REQUEST FOR INFORMATION NO. 2

Job Name: San Antonio Parking Lot Improvements, Project 2020-1309

Name of Owner: Ojai Unified School District

② Accessible Walk

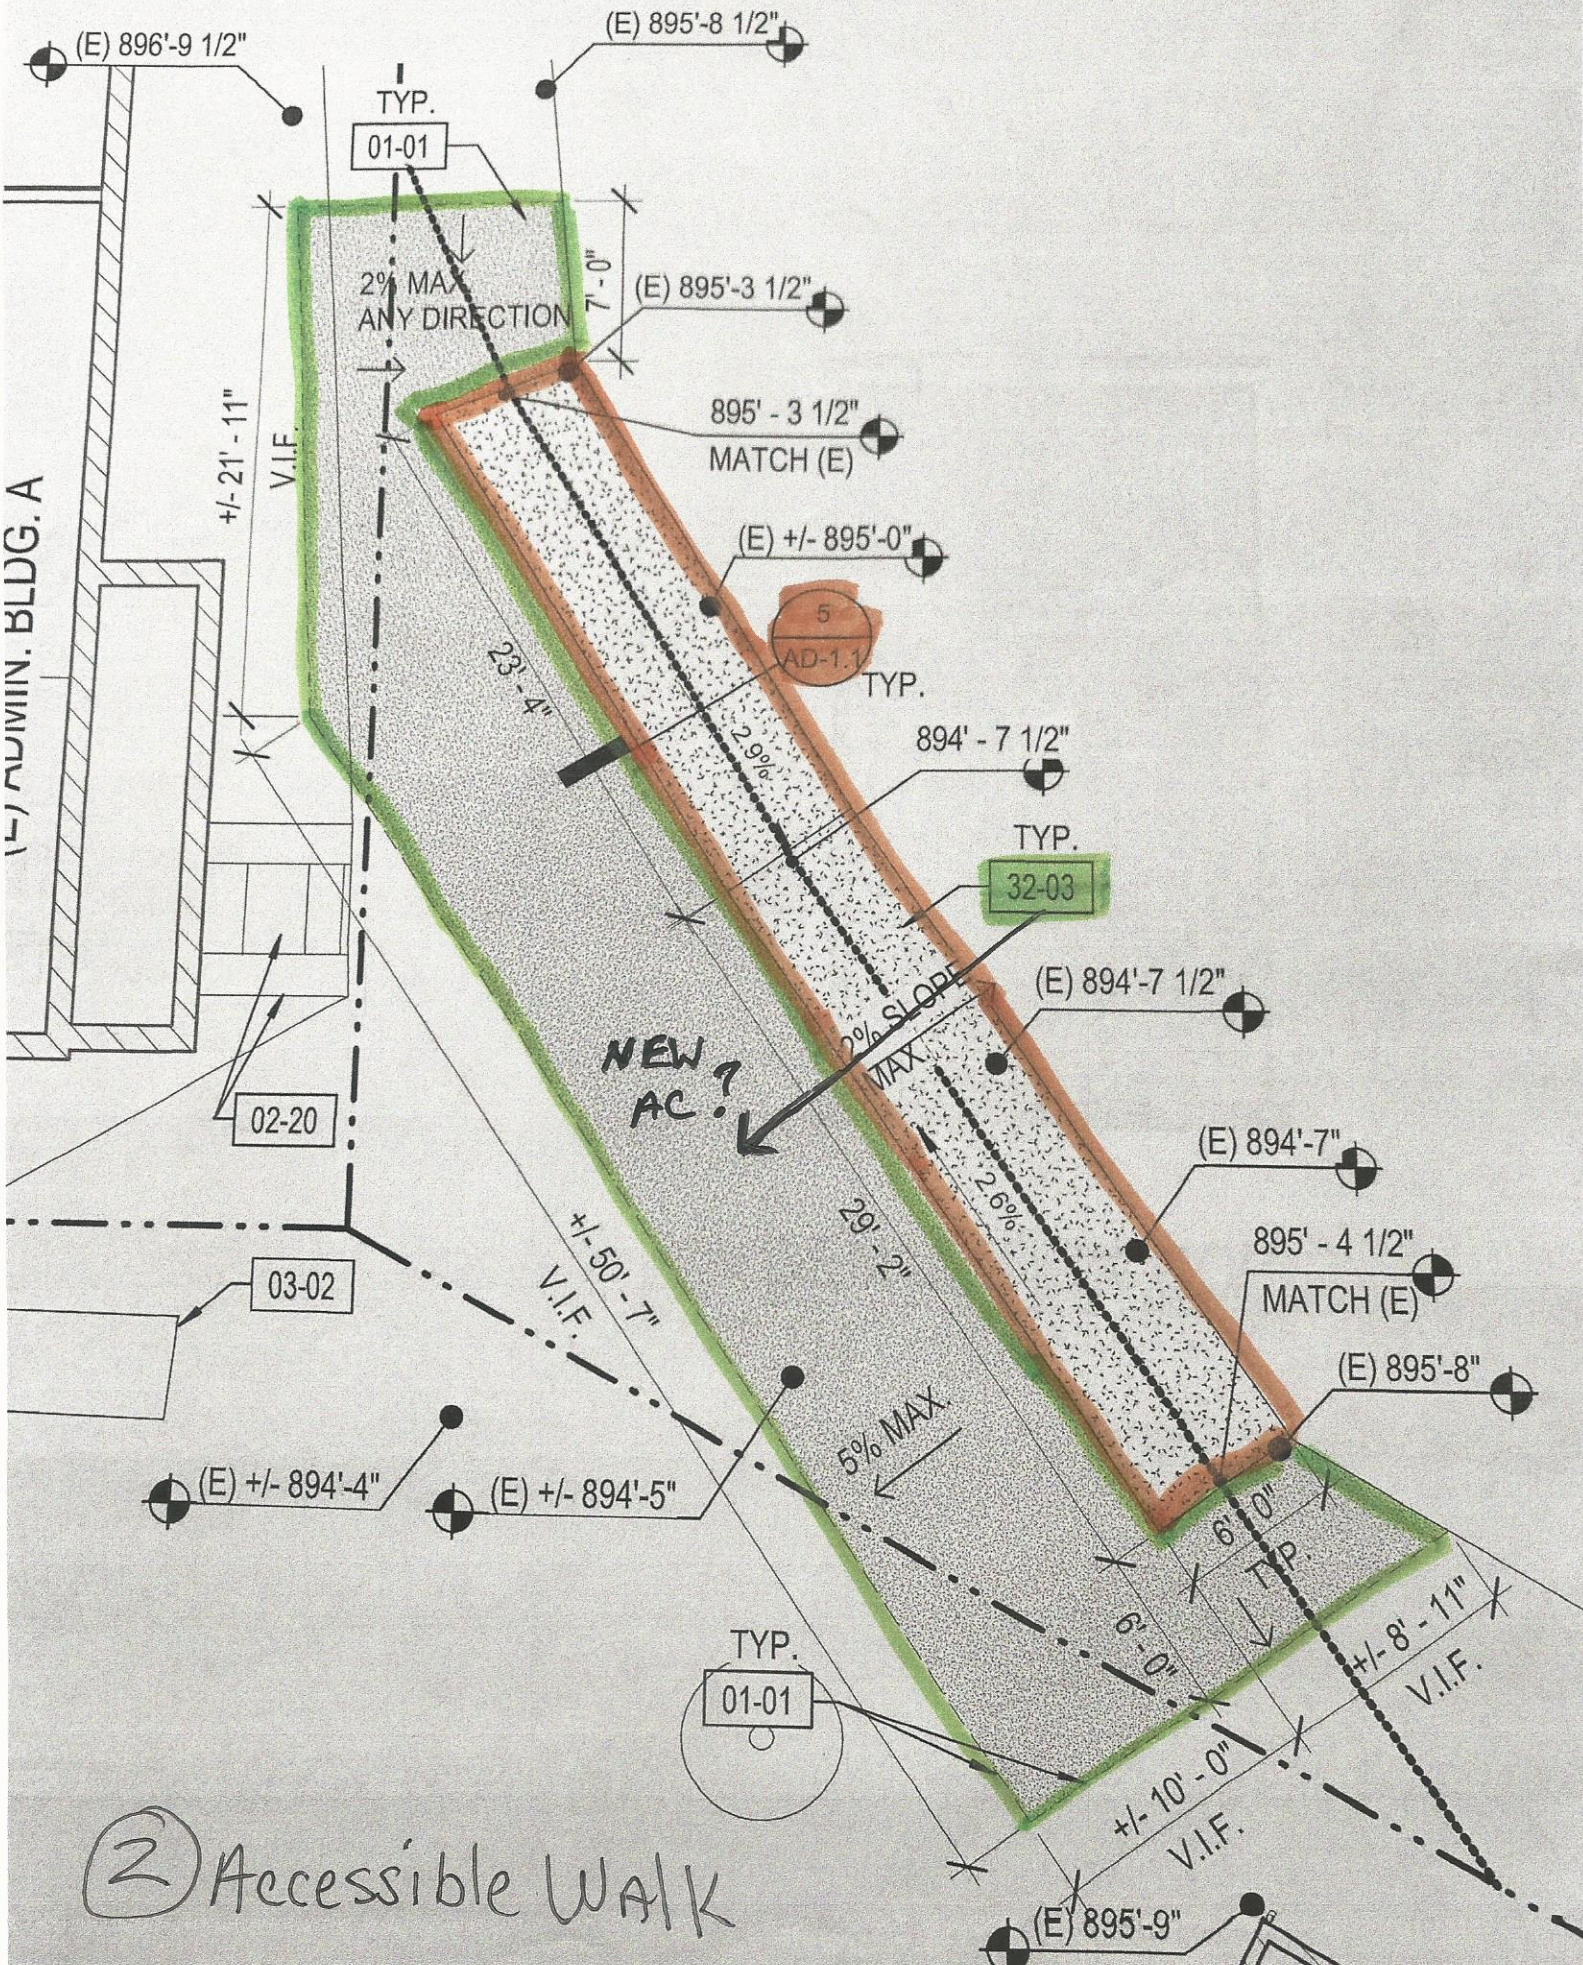
Subject : Plan Page A-1.1 Detail 2 Accessible Walk (See attached Drawing)

1. Keynote 32-03 Provide Accessible Asphalt Walk is shown in the orange outlined area, should it be in the green outlined area since AD-1.1 detail 5 shows concrete pavement in this area? Is it the school intentions to have new Asphalt and Concrete in this area as depicted on the plans?

Subject : Survey **KEYNOTE 32-03 SHOULD POINT TO THE GREEN OUTLINED AREA INSTEAD OF THE CONCRETE.**
